SECOND AVENUE SUBWAY PHASE 2

NEPA RE-EVALUATION 3

**Proposed Design Modifications:
Cost Containment Measures**

June 2025

**Figure 3.2 –106th Street Station Cutaway Diagram:
Approved Design and Currently Proposed Design Modification**

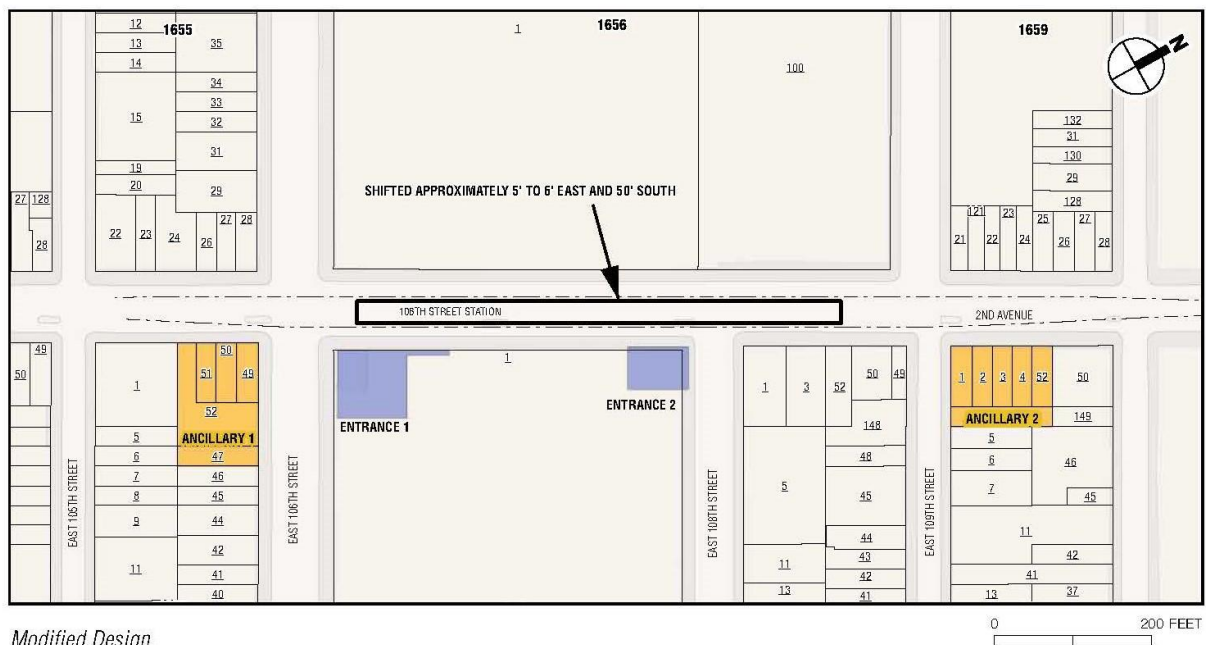
The approved design for the 106th Street Station is illustrated in [Figure 3.2](#). This station’s tracks and platform will be relatively shallow beneath Second Avenue, with the platform approximately 37 feet below street level. The station will extend from approximately East 106th Street to East 109th Street and will include two standalone, off-street entrance structures and two standalone, off-street ancillary facilities:

Figure 3.3 – Currently Proposed Design Modification at 106th Street Station:
Reduced Width for Station Box and Platform

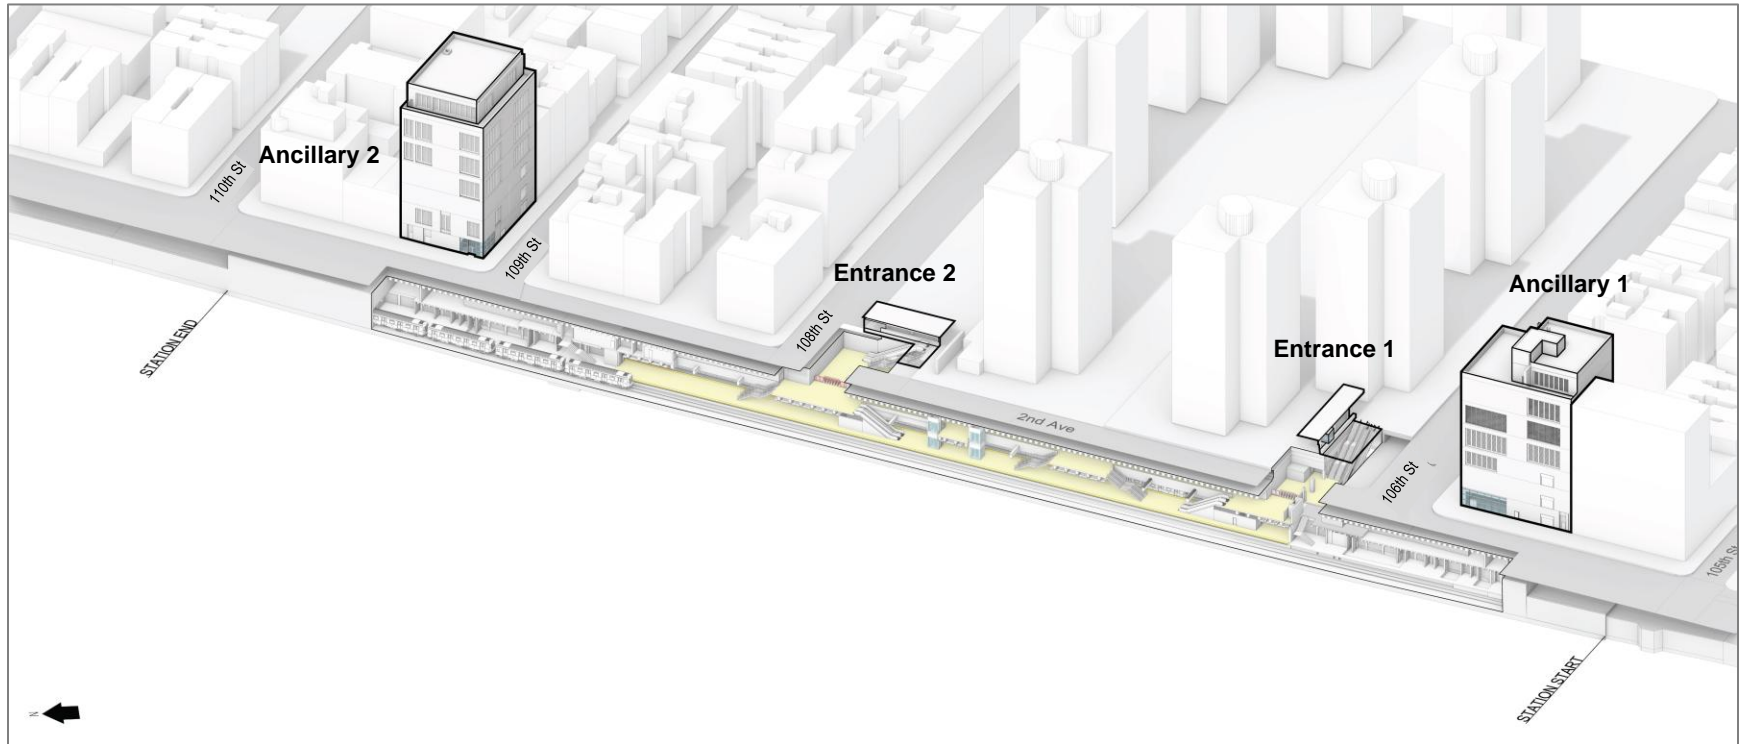
As part of the currently proposed design modifications, MTA is now evaluating a potential modification at the 106th Street Station that would reduce the width of the station box by 2 feet (see [Figure 3.3](#)). This modification would reduce the area to be excavated using cut-and-cover construction, thereby decreasing the amount of soil to be excavated and the amount of reinforced concrete needed for the station. This would also result in a minor reduction in quantities needed for finishes throughout the station. As design advances, MTA will determine whether this design modification is feasible and can be incorporated into the Project.

This design modification would reduce the width of the station platform by 2 feet, from 28 feet to 26 feet. In connection with this change, the platform stairs would be narrowed from 13 feet wide to 11 feet wide.

Figure 4.4 – Currently Proposed Design Modification for 116th Street Station: Cutaway Diagram

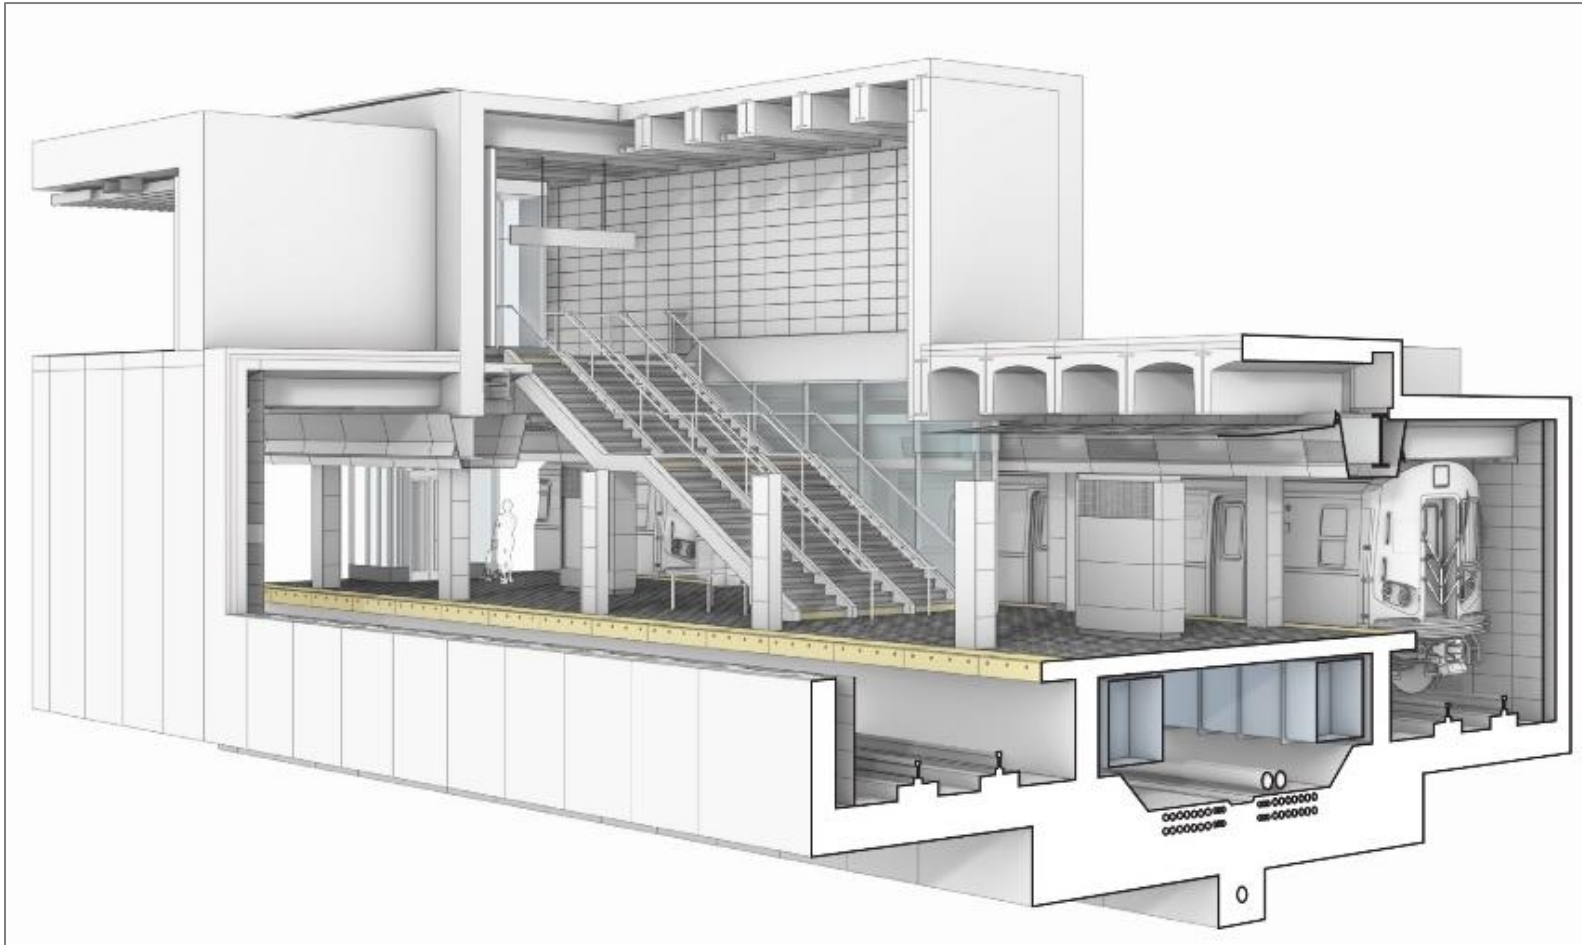
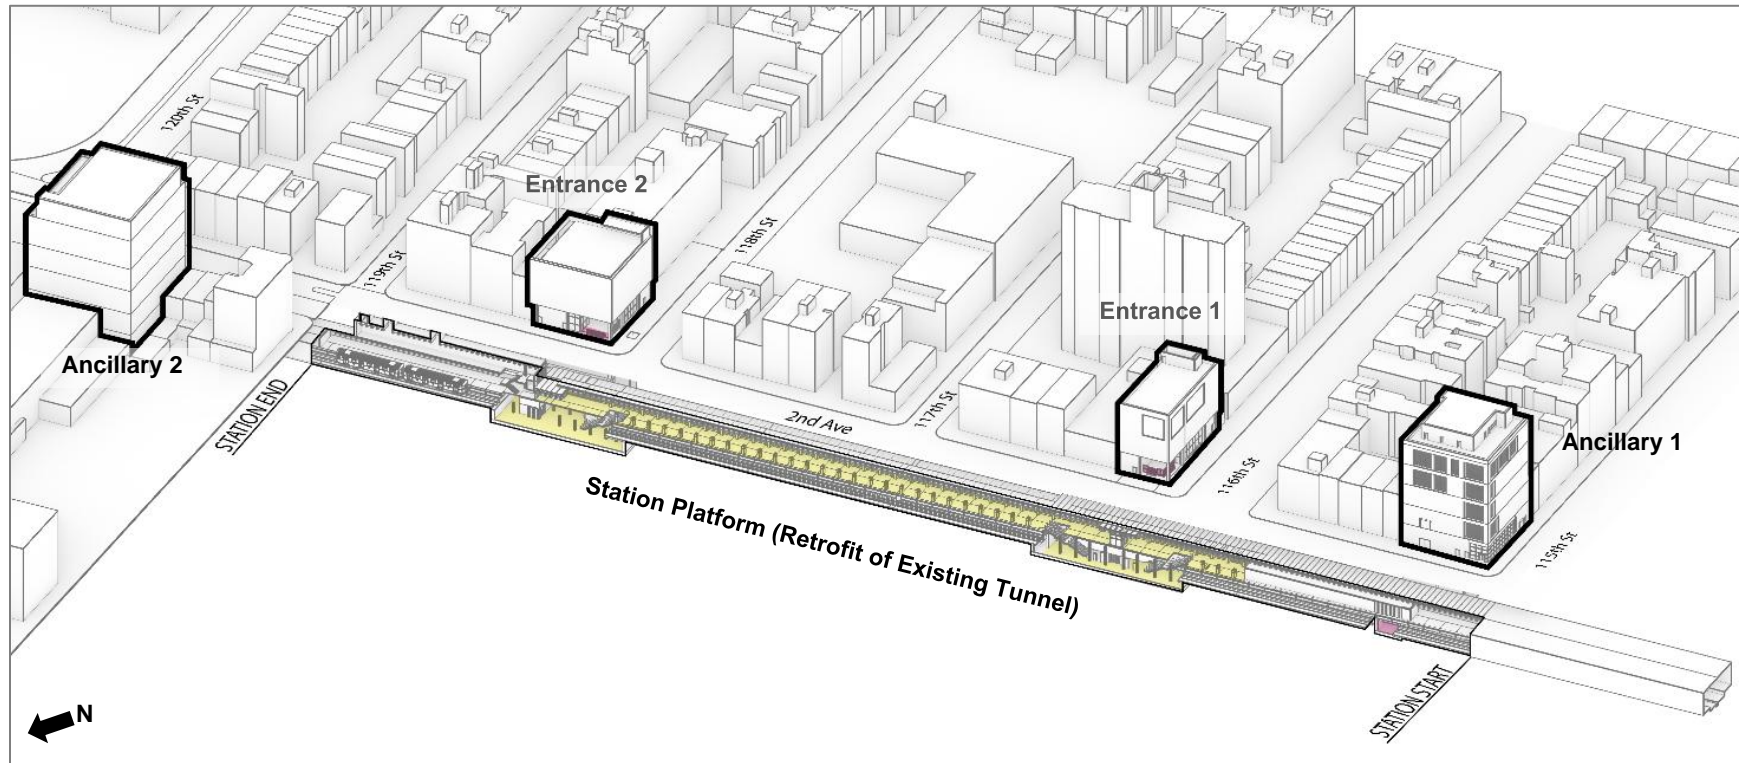
The 2020 Re-evaluation design for the 116th Street Station removed the station's full-length mezzanine and instead included four smaller, separate mezzanines above the platform. The currently proposed design modification would change the mezzanine design at the 116th Street Station so that these four separate station mezzanines are below the station platform rather than above it. As in the 2020 Re-evaluation design for the 116th Street Station, the station would not have a full-length mezzanine and instead would have four smaller, separate mezzanines—mezzanines for public use at the station's two entrances and mezzanines serving back-of-house space at the station's two ancillary facilities.

With the currently proposed design modification for the 116th Street Station, the mezzanine segments connecting to the station's entrances (and the separate, non-public mezzanine segments serving back-of-house spaces) would be 15 feet below the platform level rather than above the platform level.

In addition, with the currently proposed design modification for the 116th Street Station, both station entrances would be reconfigured as elevator-only entrances. Elevators would provide the most efficient connection between the 116th Street Station's street-level entrances and its mezzanine level below the platform. The mezzanine would be approximately 56 feet (five stories) below street level. Access to this level via escalators would require a series of "switchback" escalators that would be inefficient for moving large volumes of people. In contrast, the proposed elevators at the station would be high-capacity,² high-speed elevators that can quickly move people between the mezzanine and the street. Each entrance would have multiple elevators (four at Entrance 1 and three at Entrance 2), providing a high level of redundancy.

**Figure 4.11 – Comparison of Cut-and-Cover Construction Area at 116th Street Station:
2018 Supplemental EA Design, 2020 Re-evaluation Design, and
Currently Proposed Design Modification**

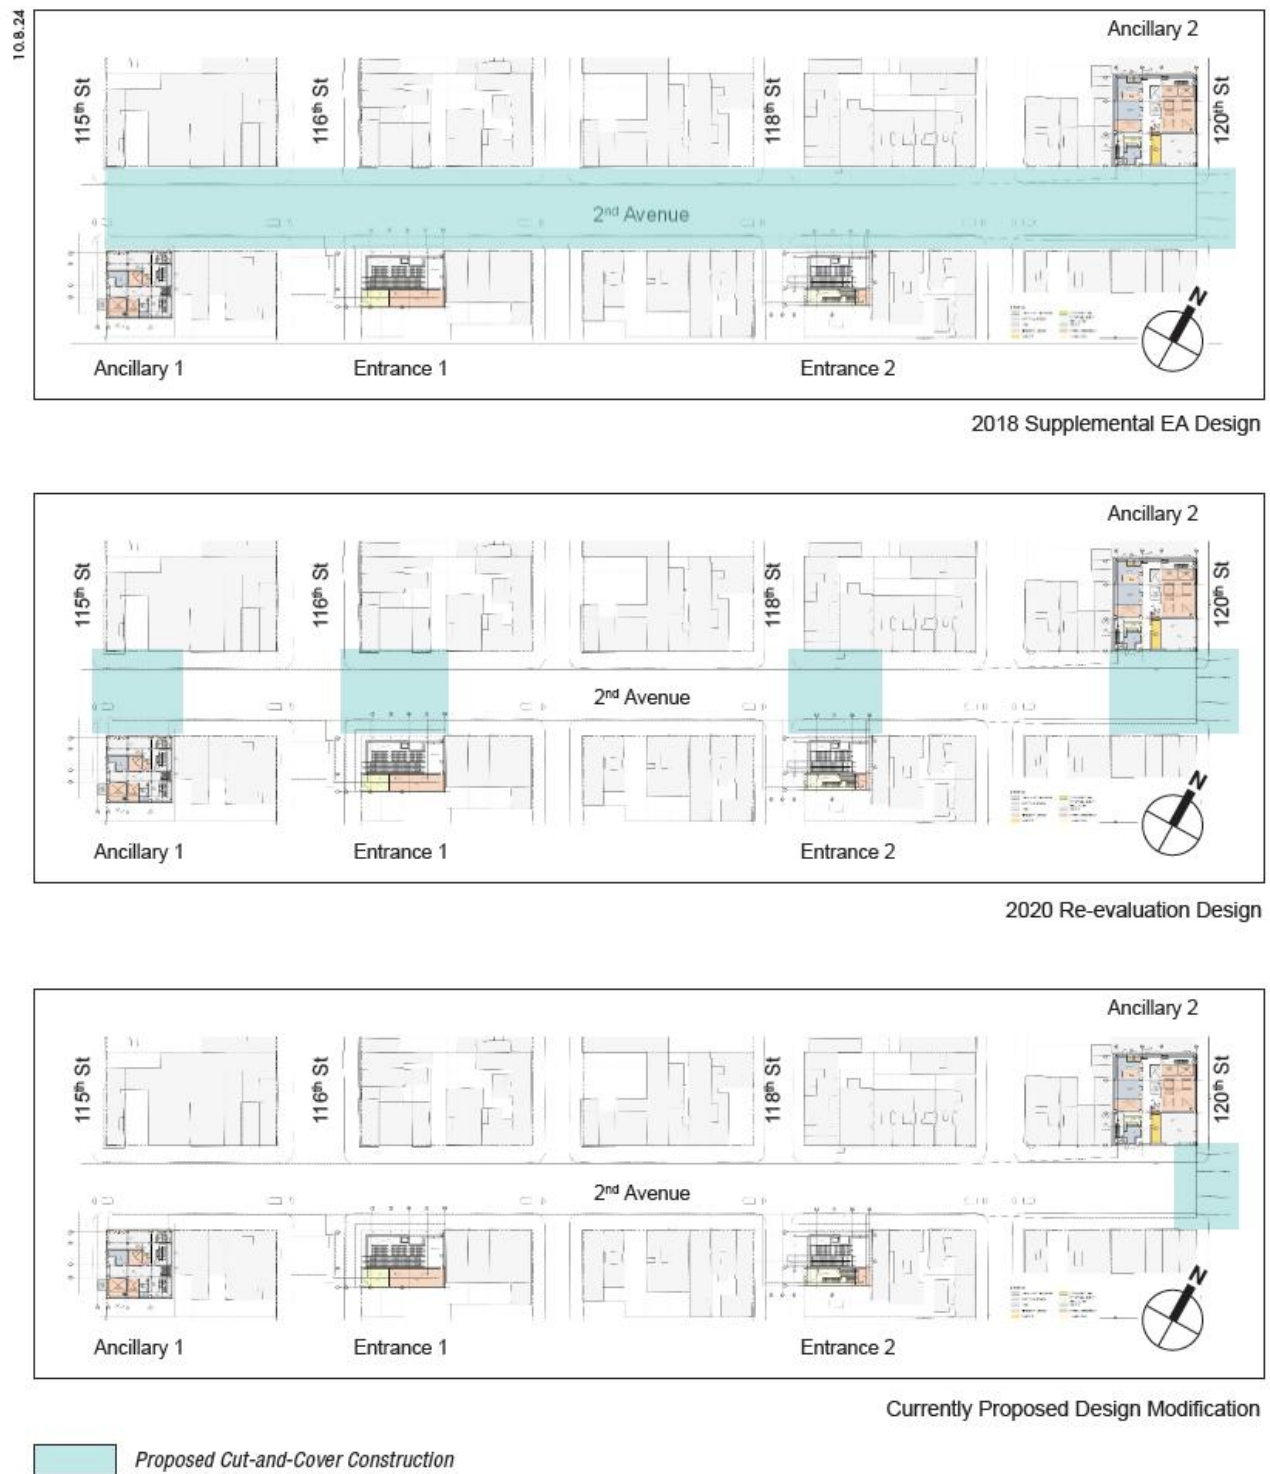
In combination, the currently proposed design modifications at the 116th Street Station would eliminate most areas of cut-and-cover construction and associated utility relocation in Second Avenue. [Figure 4.11](#) illustrates the areas of cut-and-cover construction anticipated with the 2018 Supplemental EA design, the 2020 Re-evaluation design, and the currently proposed design modification.

Figure 5.2 – Proposed Modifications to Utility Tunnel T3
at West End of 125th Street Station (Park Avenue): Section View

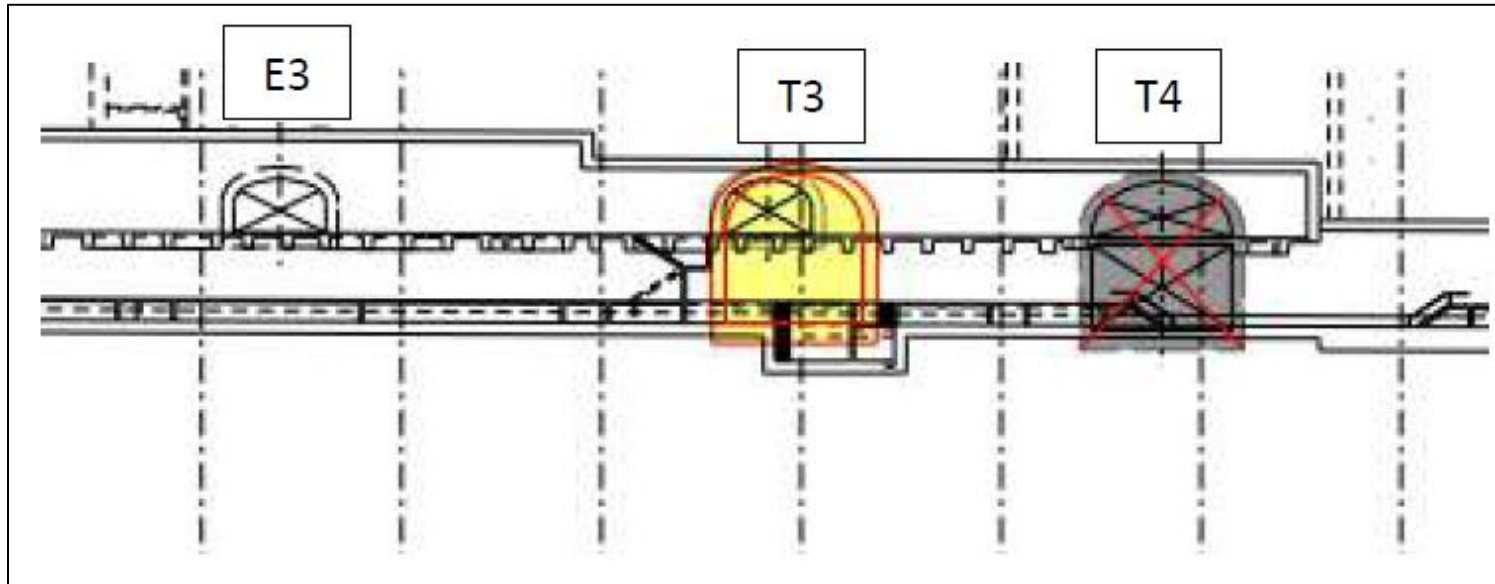
The approved design also includes three utility tunnels providing connections between the station's mezzanine level and the ancillary facilities. These three tunnels are Tunnels T1 and T2 at the east end of the station and Tunnel T3 at the west end of the station under Park Avenue. These tunnels will extend south from the station at the mezzanine level to connect to the ancillary facilities. As part of the currently proposed design modifications, to compensate for the previous elimination of a fourth utility tunnel, Tunnel T4, at the 125th Street Station, the current design modification includes enlarging Tunnel T3 to the size previously contemplated for Tunnel T4. Tunnel T3 will be at the west end of the station, beneath Park Avenue, and will connect back-of-house spaces on the mezzanine level to Ancillary 2. The below-grade area where the enlarged Tunnel T3 will be located is a location that was originally contemplated for a connection to Entrance 1 in the 2004 FEIS design. [Figure 5.2](#) illustrates the proposed change to Tunnel T3.

The currently proposed design modification would increase Utility Tunnel T3 to the size shown in yellow

Figure 5.3 – Proposed Modifications to Utility Tunnel T2 at East End of 125th Street Station: Section View

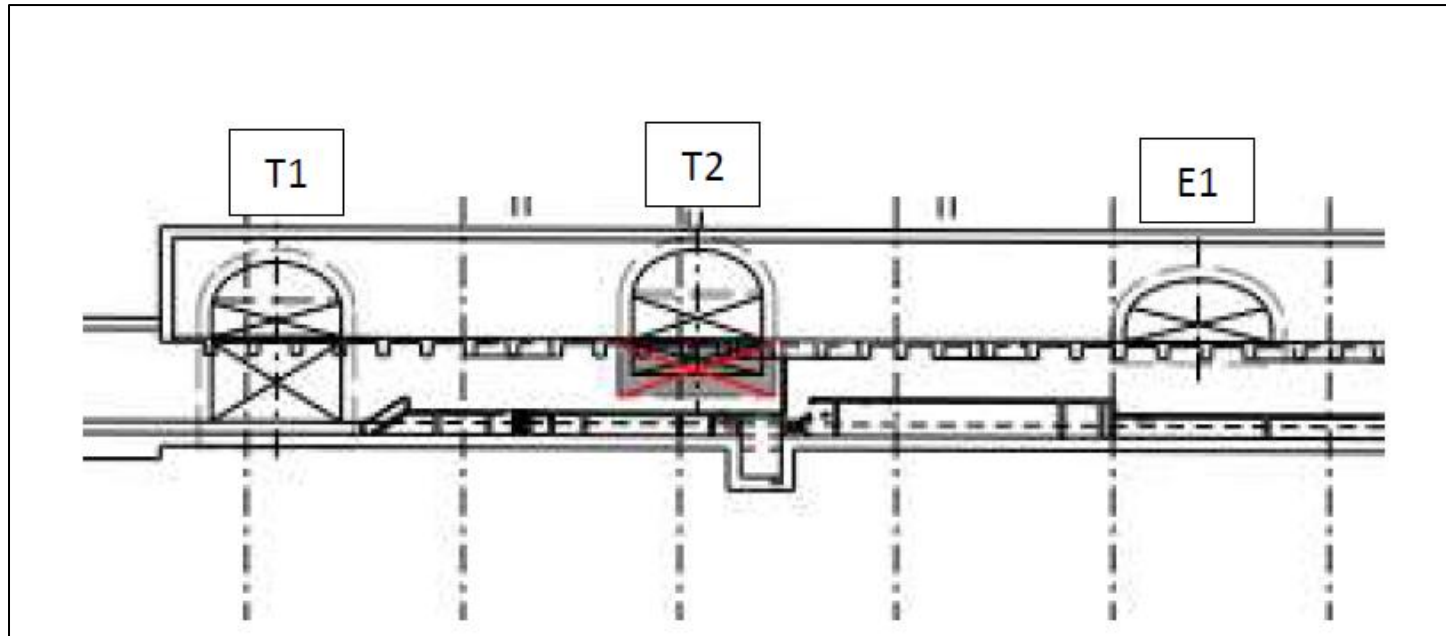
At the east end of the 125th Street Station, the currently proposed design modification includes a reduction to the height of Tunnel T2, one of the utility tunnels connecting back-of-house spaces on the mezzanine level to Ancillary 1. This would reduce the amount of rock excavation required and the amount of reinforced concrete needed during construction of the station. The design modification would not result in changes to the function or accessibility of Tunnel T2 and would not affect the design of the station platforms, mezzanine, or back-of-house areas. [Figure 5.3](#) illustrates the proposed change to Tunnel T2.

The currently proposed design modification would reduce the size of Utility Tunnel T2

Figure 5.4 – Currently Proposed Design Modification: Utility Tunnels at 125th Street Station

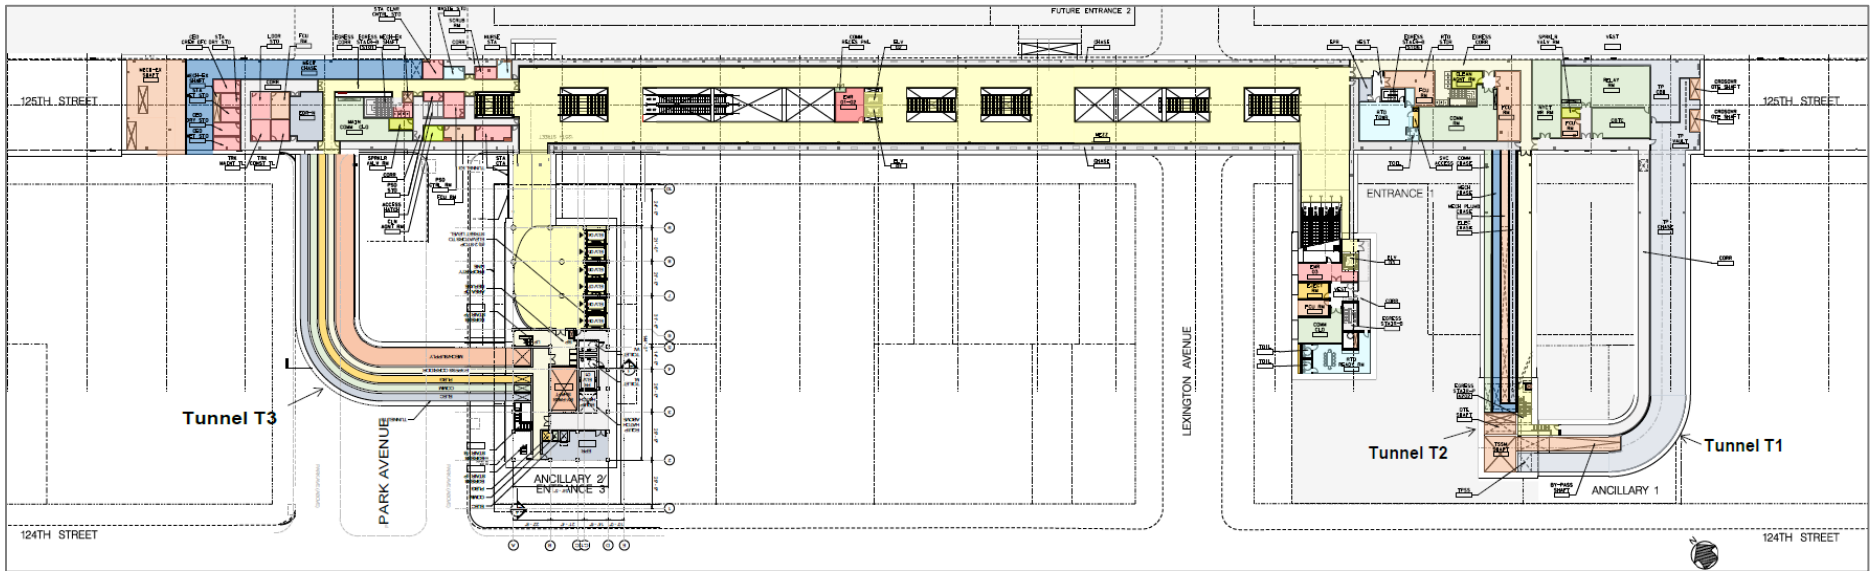
[Figure 5.4](#) provides a plan view of the 125th Street Station showing the locations of the three utility tunnels with the currently proposed design modifications.
